MARCH 20th 2024 MRC Draft M14B for LTRTP –

PJM Manual 14B:

PJM Region Transmission Planning Process

Revision: 5X

Exhibit 1: *24-Month Reliability Planning Cycle*

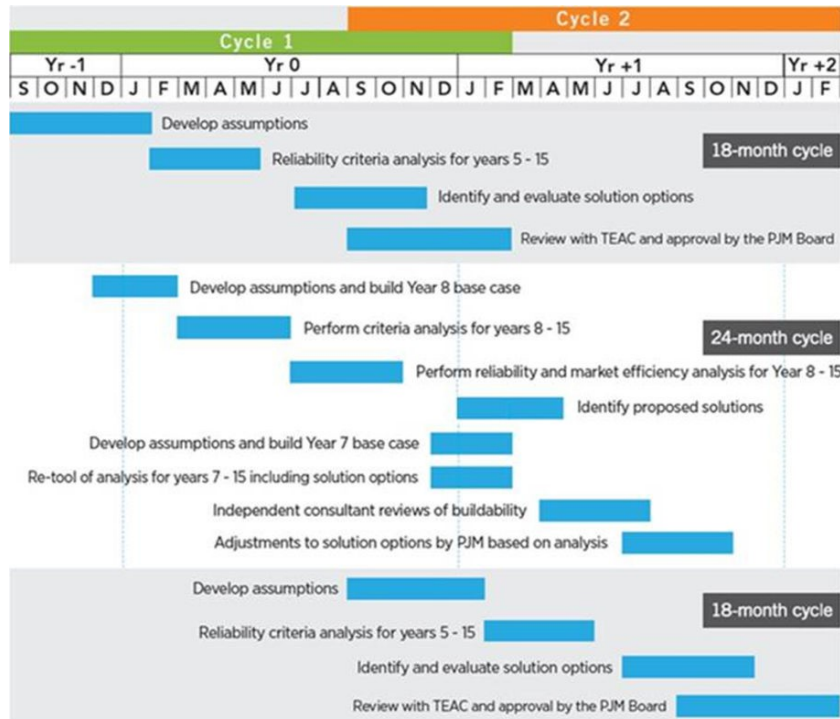
Exhibit 1 shows the ~~15-year reliability~~24-month Reliability planning process which is comprised of 18-month near-term and 36-month long-term cycles to covered for the 15-year RTEP 15-year planning horizon. ~~The reliability~~This 24-month planning process integrates ~~the upgrades noted above with~~ information transparency, stakeholder input and review, and PJM Board of Manager approval into the selection of transmission enhancements or expansions~~approvals~~. Activities shown on this diagram and their timing are for illustrative

~~The 24-month planning process is made up of overlapping 18-month planning cycles (Refer to Exhibit 1) to identify and develop shorter lead-time transmission upgrades and one 24-month planning cycle to provide sufficient time for the identification and development of longer leadtime transmission upgrades that may be required to satisfy planning criteria. Consistent with the requirements of the NERC TPL Reliability Standards the 24-month planning process includes both near-term (years one through five) and long-term (years six through fifteen) assessments of the transmission system as described below.~~

Exhibit 2: Base Case Development

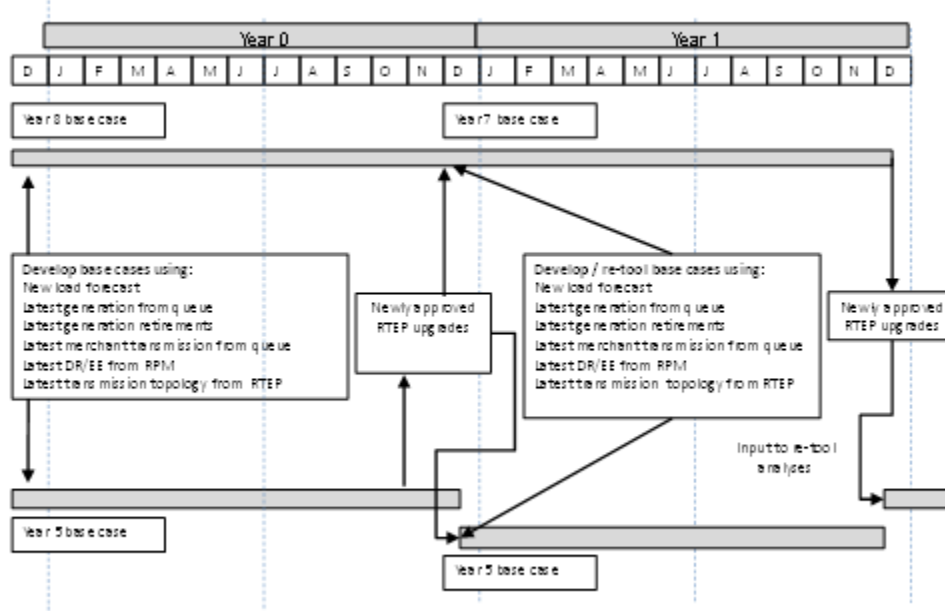
~~Violations and proposed solutions to address them are developed by stakeholders and PJM staff during the first year of the 24-month planning cycle. As shown in Exhibit 1 2, during the latter portion~~second year of the ~~second and third years of the 36~~24-month planning cycle, the base case ~~developed~~used for the ~~year-8~~long-term analysis during the first year (i.e., ~~now year 7~~) is updated to reflect the latest assumptions about load, generation, ~~demand response, energy efficiency~~DR, EE, and transmission topology. Long-term criteria analysis is ~~then~~ completed on ~~these updated year-8 base cases during the subsequent year.~~

~~this base case during the second year of the 24-month cycle. A combination of a full AC power flow solution and linear analysis, as described in this manual, is again used to determine the loading on facilities for years 7 through 15. Potential violations identified during the second~~first year ~~of are validated and the year-8 analysis~~proposed solutions to address those violations are ~~considered for system reinforcement and possible inclusion in the long-term competitive transmission solicitation window. Solutions to less complex needs may be sought in the near-term competitive transmission solicitation window~~refined during the ~~second year of the 24-month planning cycle.~~ An independent consultant may be used to develop an independent cost estimate and evaluate the constructability of proposed solutions ~~from these windows.~~ Results from these long-term analyses, including potential violations and their solutions, are reviewed with the TEAC throughout the ~~36-month planning process~~24-month planning process. ~~Ultimately, any required long-lead time solutions that are identified through this planning process are presented to the PJM Board of Managers for approval.~~

~~Ultimately, any required Short-term Projects or Long-lead Projects that are identified and selected through the reliability planning process are presented to the PJM Board of Managers for approval. Once approved, PJM will periodically review the continued need for Long-lead Projects based on the most recent planning assumptions.~~
